APPLICABILITY: 2015-16MY Outback

NUMBER: 07-113-16

SUBJECT: Gear-Clashing / Grind Sound from Power Rear Gate (PRG) Assembly

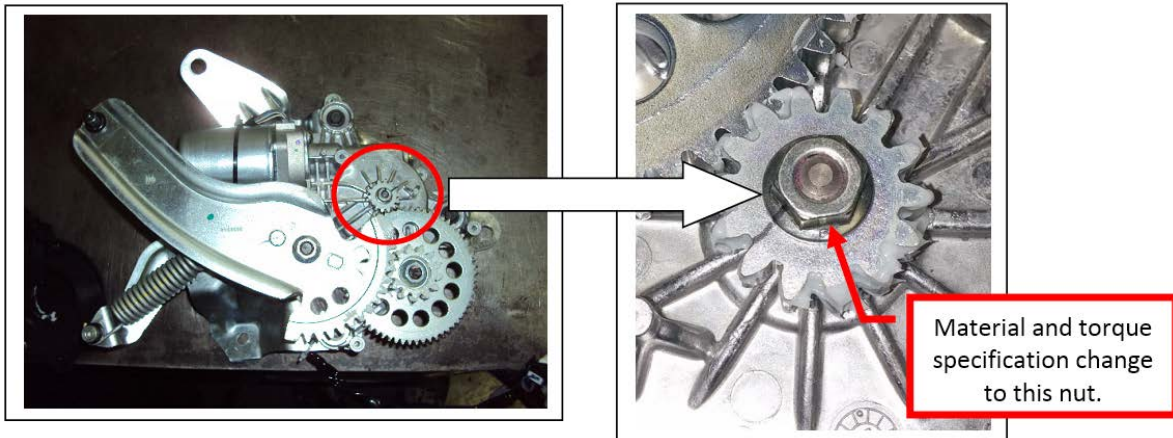
This bulletin announces a design change to the PRG mechanism in response to a small number of customer concerns regarding a gear-clash or grinding -type sound heard when opening or closing the rear gate. A material change and revised torque specification have been made to the drive gear retaining nut shown in the photos below.

The new PRG assembly was incorporated into production starting with VIN G*311904.

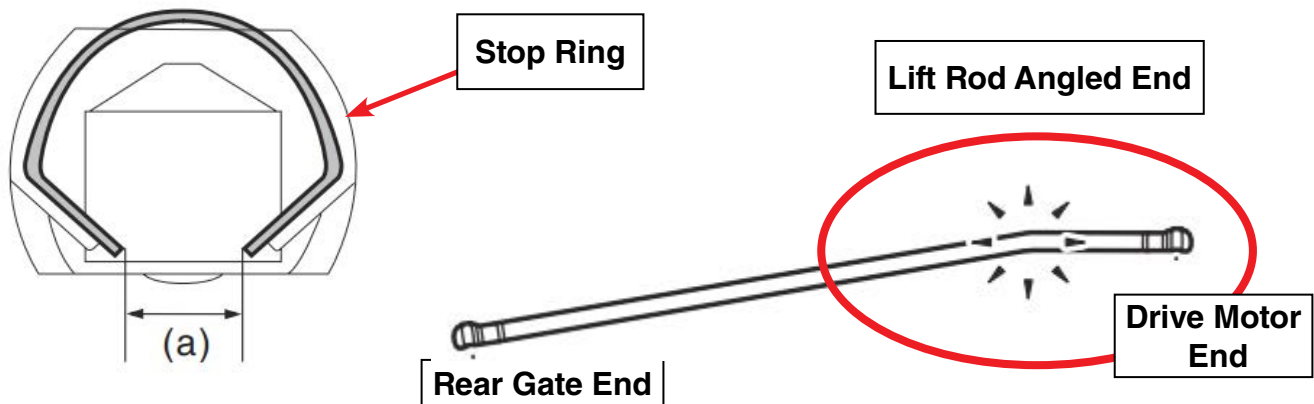
- The PRG assembly pictured above is NOT field serviceable and must be replaced as a unit. Do not attempt to repair it.
- Whenever removing the lift rod, the stop rings (retaining clips) must be replaced as they are **one-time use items**.
- When installing the new stop rings onto the lift rod, be careful to not use any excessive force which may deform them. Dimension (a) in the illustration below must be between 6.4 - 7.2mm (.250 - .280").
